Parks, Open Space and Trails Committee (POST)

Wednesday, February 16, 2022

| 4:07 | 3. Discussion of Basalt River Park Phase 2 with Connect One Design <ul style="list-style-type: none">▪ Review Park Details and Provide Recommendations |

SIGNAGE PLAN
L.4.01

Handwritten notes:
 CAD Sign Concept presented at last post mtg

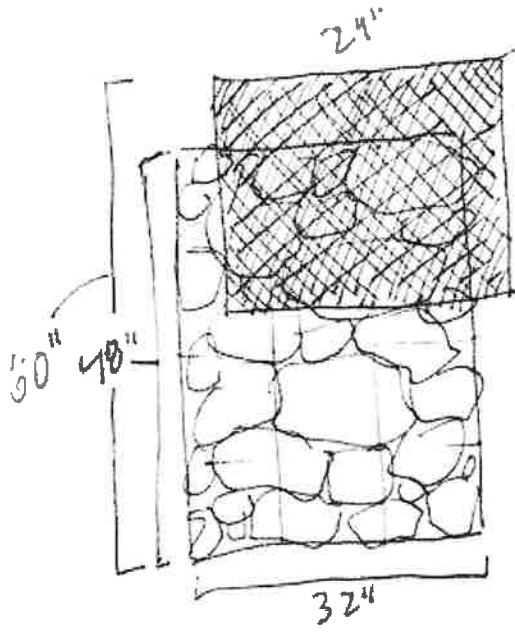
Adjusted Park Sign Design- More Economical Version Perviously Reviewed by POST
